Plan Reviewer for Horry County

Villas at The Gates
 Dawol Homes

Villa 6
 Myrtle Beach, SC

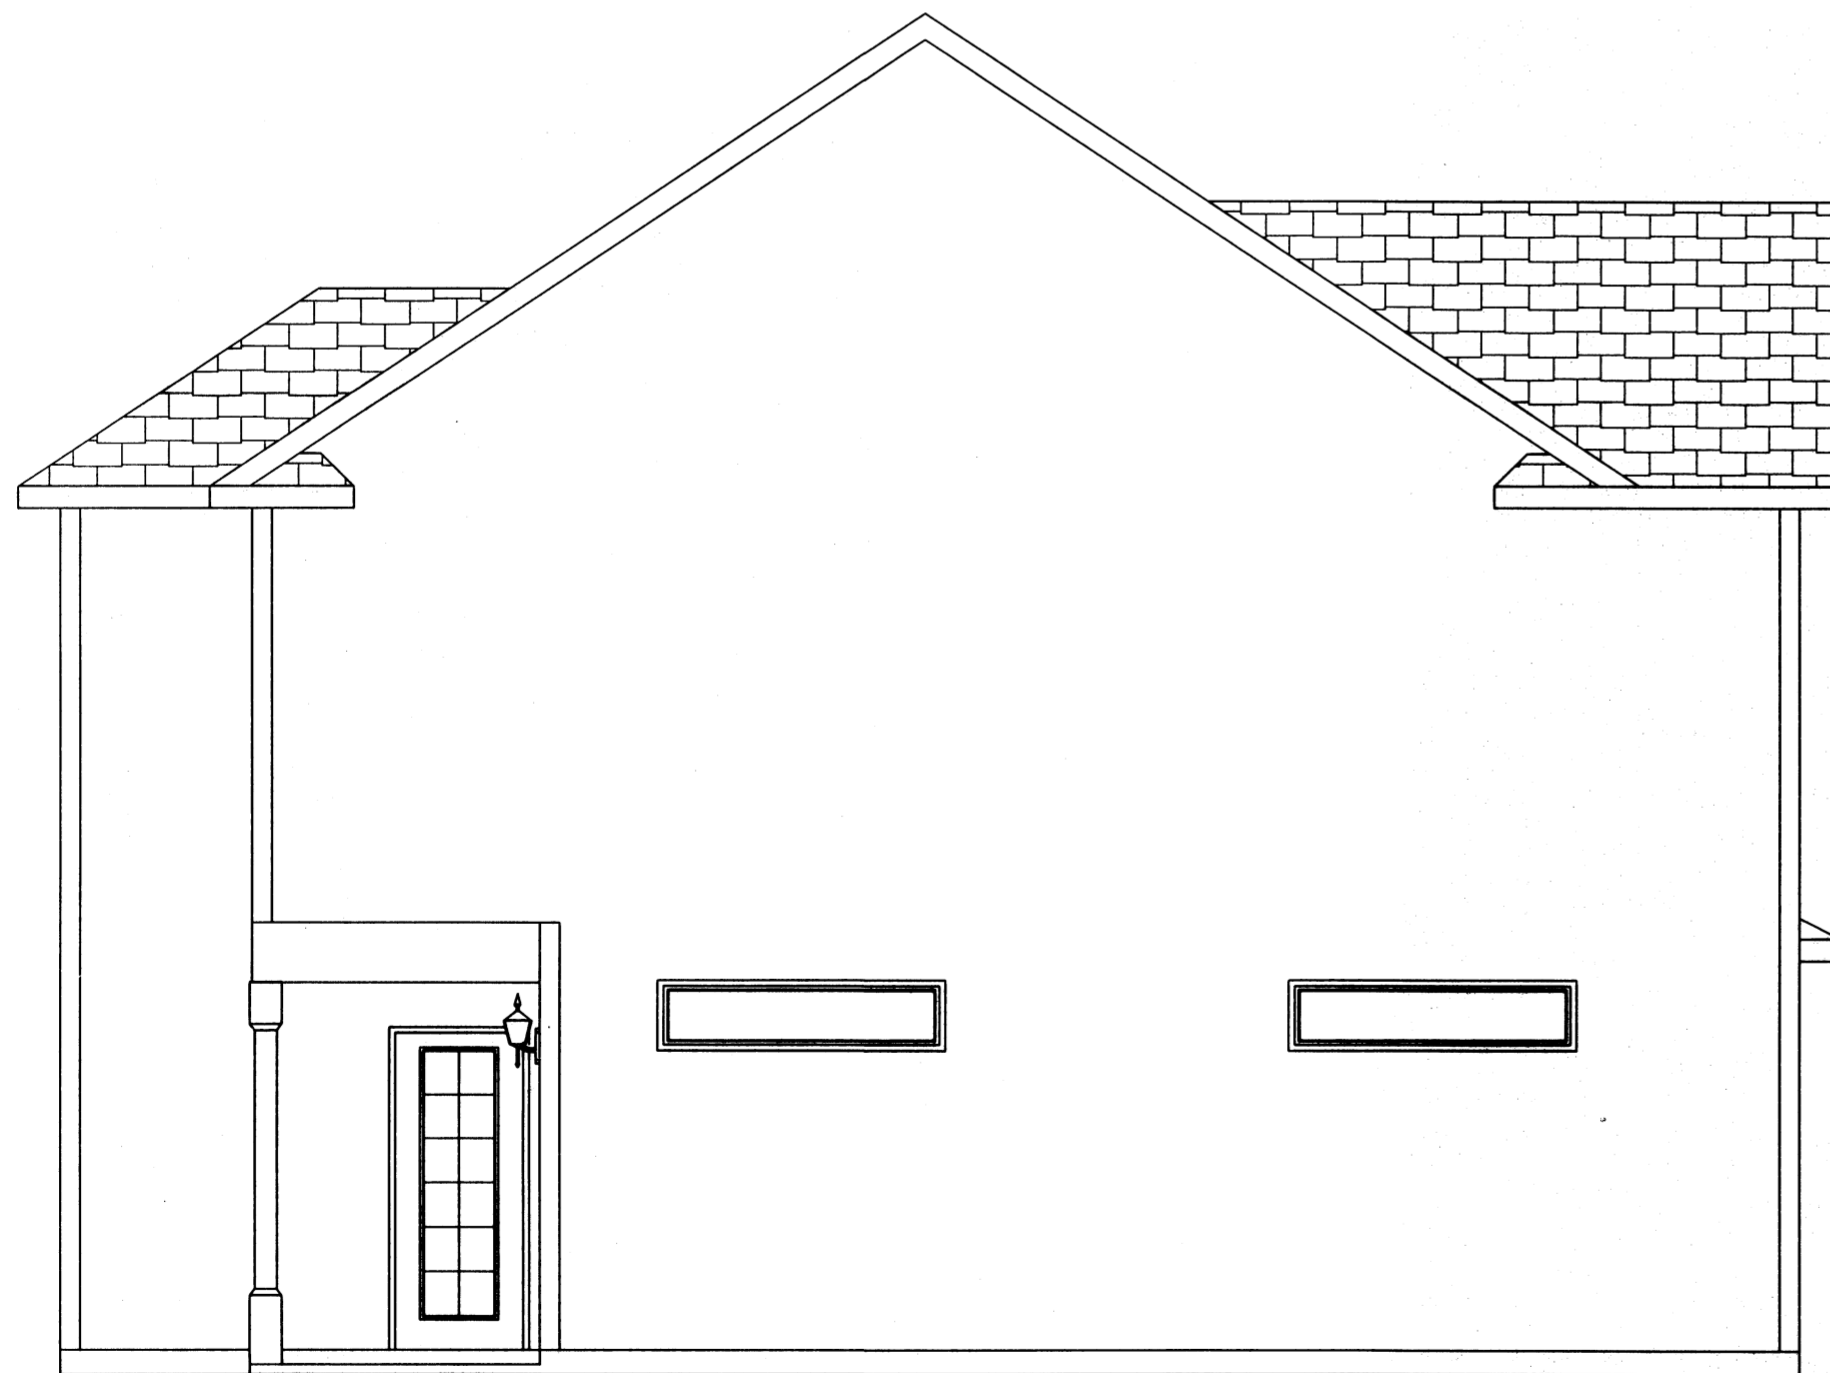
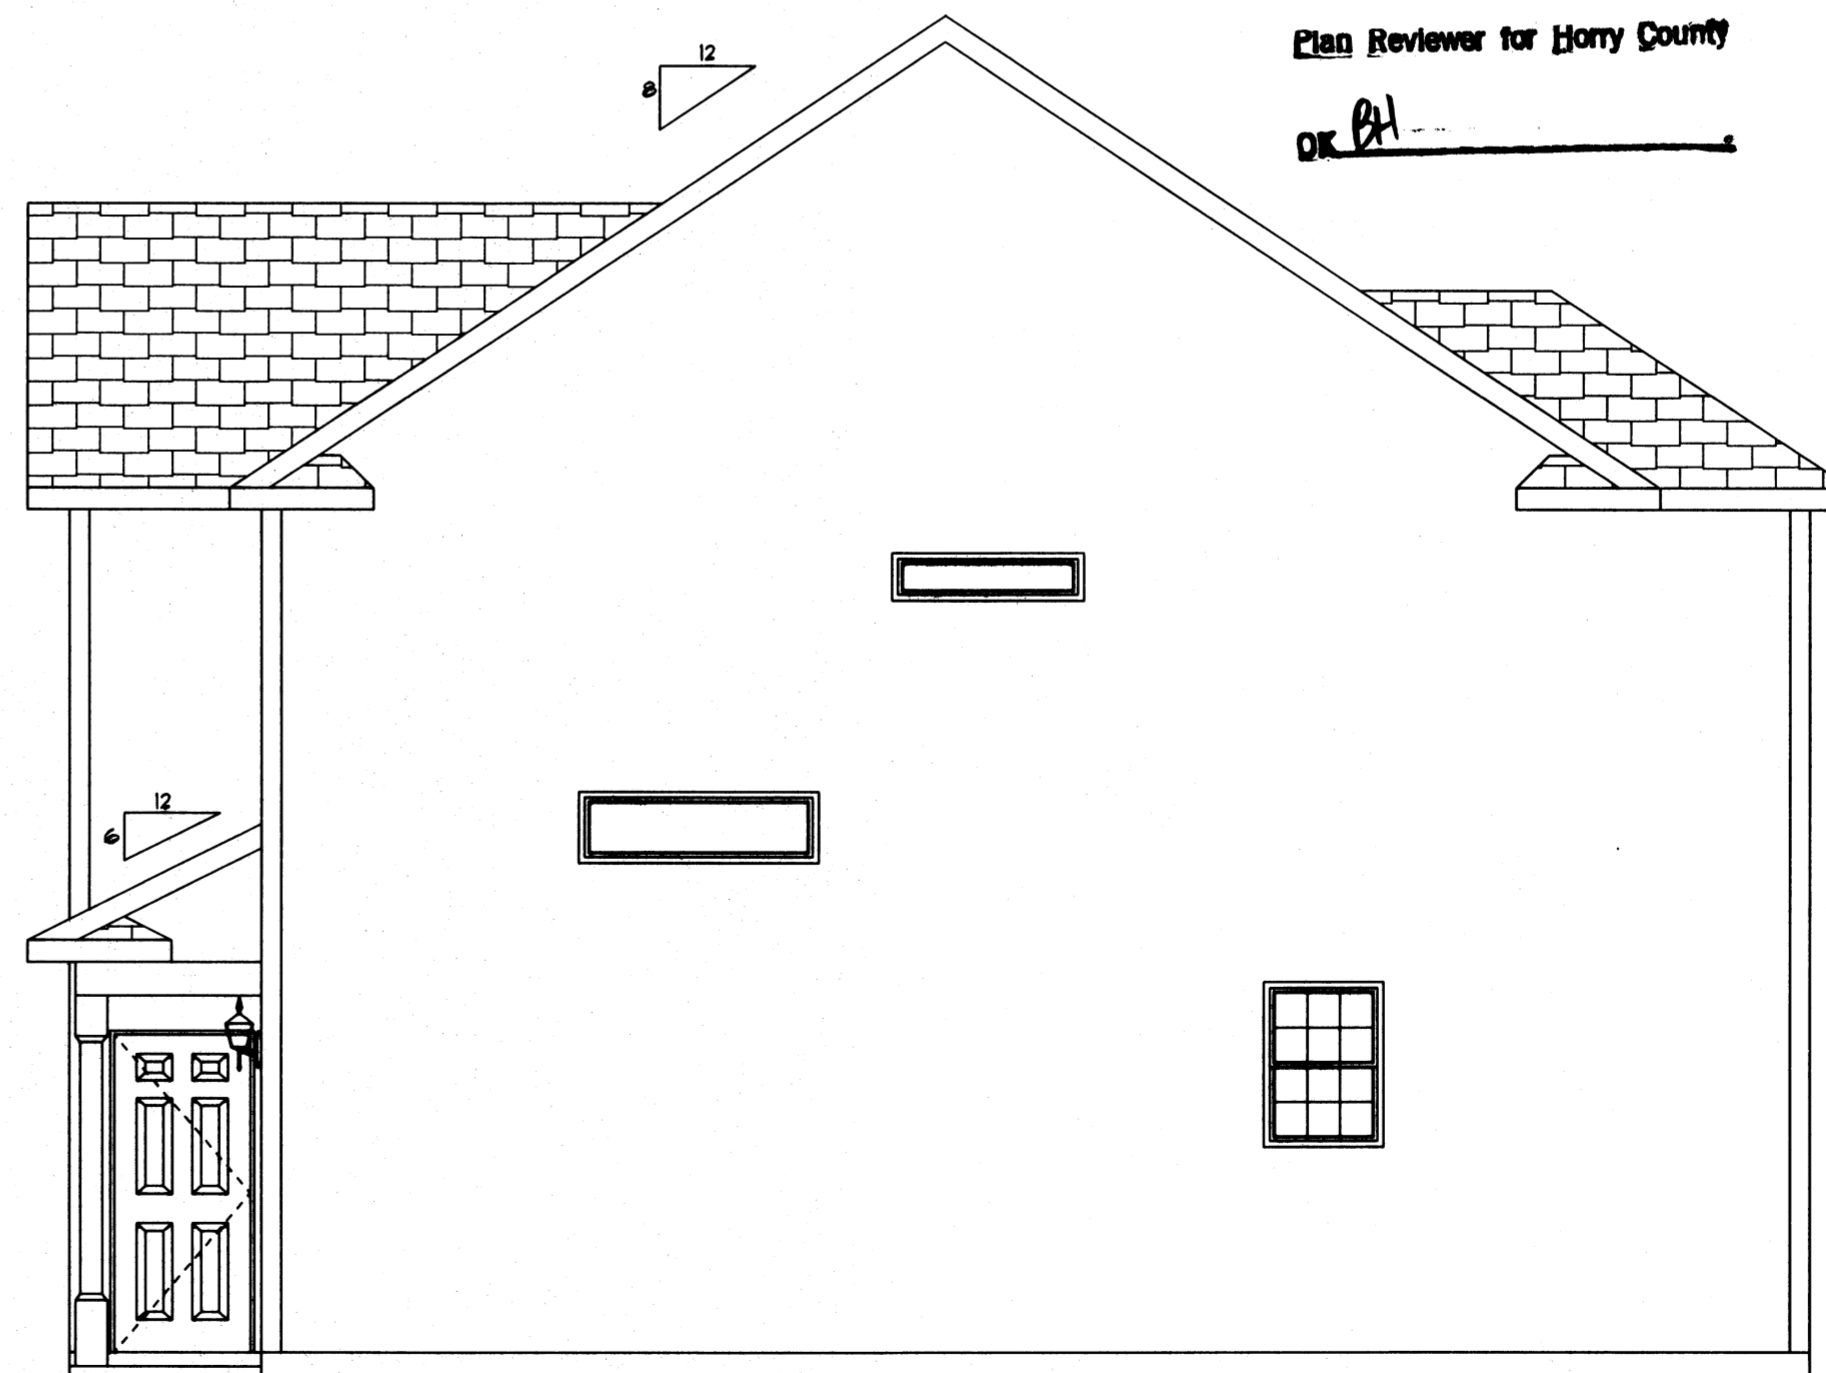
OK *PH*
